REQUEST FOR INFORMATION RESPONSE

RJR Project No.: 14104 VA Design Contract No.: VA528-15-C-0001 VA Construction Bid No.: VA242-17-B-0004	Date: 2016-12-14
Client: Bath VA Medical Center	Prepared By: Jonathan F Fabian
RJR Document: RFI-14104-C001.REV00 Request For Information Response	
Design Phase: Construction Services

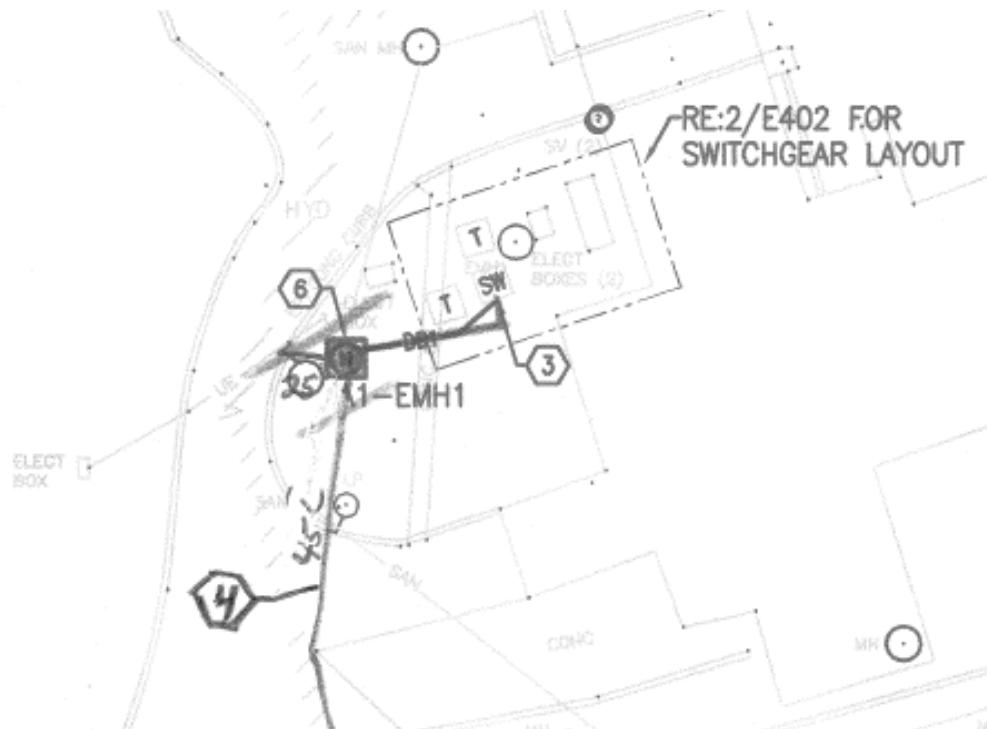
Q8. Drawing FA101:

a. General Requirements Note 1:

i. "New Campus Wide FA System to be installed"? Is the FA System in this part of the building part of another FA Project? A note on the same drawing also states that the Pull Station and Horn are By Others? Is this accurate?

A8. At the time of design, a new campus wide fire alarm system was in the process of being designed and installed. It is the A/E's understanding that that fire alarm project has been subsequently completed.

As a part of this electrical upgrade project, it is the contractor's responsibility to complete all work shown on drawing FA101, coordinating as necessary with the campus's new fire alarm system.

The pull station and speaker strobe indicated by the note on detail 2 of drawing FA101 were to have been previously installed by others as a part of the fire alarm upgrade project. It is the responsibility of the contractor for this electrical upgrade project to relocate them as shown on the contract drawings.
